**From:** Detterman, Mark, Env. Health  
**Sent:** Thursday, February 23, 2017 4:10 PM  
**To:** 'David Siegel'  
**Cc:** michael beritzhoff; Kasey Cordoza; Andrew Savage  
**Subject:** RE: 2449 Santa Clara, Alameda RO0003225

**From:** David Siegel [mailto:dave@eras.biz]  
**Sent:** Monday, February 13, 2017 10:25 AM  
**To:** Detterman, Mark, Env. Health <Mark.Detterman@acgov.org>  
**Cc:** michael beritzhoff <mikeberitzhoff@sbcglobal.net>; Kasey Cordoza <kasey@eras.biz>; Andrew Savage <andrew@eras.biz>  
**Subject:** 2449 Santa Clara, Alameda RO0003225

Hi Mark, as requested in the January 18, 2017 letter I have attached a revised Figure 2 from the August 24, 2016 workplan. Three soil borings were added to the Figure.

**SITE PLAN w/PROPOSED BORINGS**

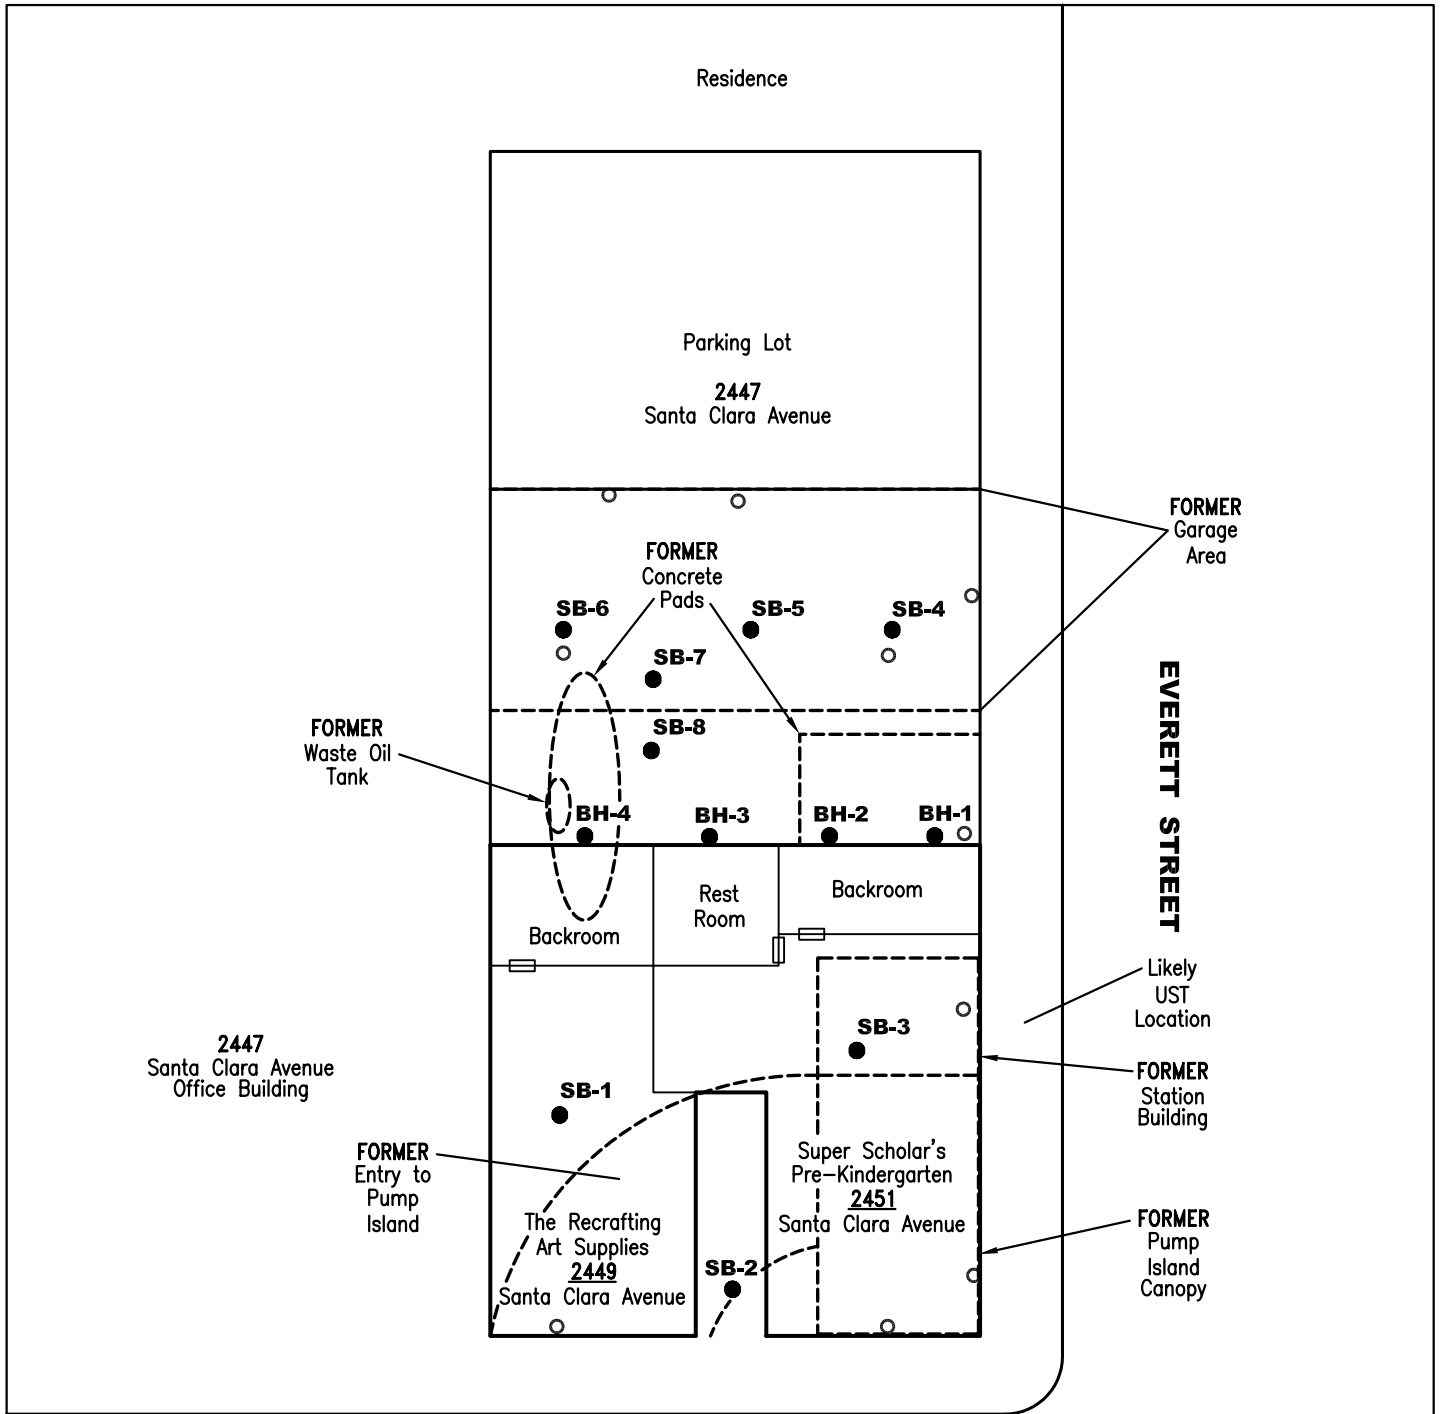
Unless I am misreading your email, it appears that your email is substantially changing the scope of the approved work plan, namely moving from collecting soil samples in the 0 – 5 foot depth interval to just collecting groundwater samples from the proposed bores. ACDEH has two concerns with this approach:

- 1) The LTCP requires soil sampling in both the 0 -5 and the 5 – 10 foot depth intervals as a site is characterized. I am in agreement that the vast majority of soil samples to date have very limited soil contamination; however, the source areas have not been substantially identified or explored and require characterization to confirm they are similar to soils previously sampled and analyzed. The collection of additional groundwater samples will help characterize the extent of any groundwater plume, also an LTCP requirement.

- 2) The email also appears to limiting the TPH analysis at areas that have not been explored to TPHg only. Since no one is aware that it really was a “gasoline” dispensing facility only, it is reasonable to analyze new soil samples for the full range of TPH. One method to limit costs would be to do a hydrocarbon range analysis in order to determine the appropriate TPH range to analyze for at the site.

Let me know how you want to proceed. Due to these substantial changes, ACDEH will need to require at least a letter containing the rationale and the figure, as well as the standard “Submittal Acknowledgement” statement (replacing the perjury statement) as mentioned in the January letter.

Regarding the proposed laboratory analyses, the August 24 workplan indicated a selected soil sample from the 0-5 foot depth interval would be analyzed for TPH-oro and BTEX. Since the real issue is TPH-dro and TPH-oro in GROUNDWATER, the groundwater samples will be analyzed for those contaminants with and without silica gel cleanup AND for VOCs which include BTEX. Finally the samples from the four borings near the former pumps and likely fuel UST locations will also be analyzed for TPH-gro.
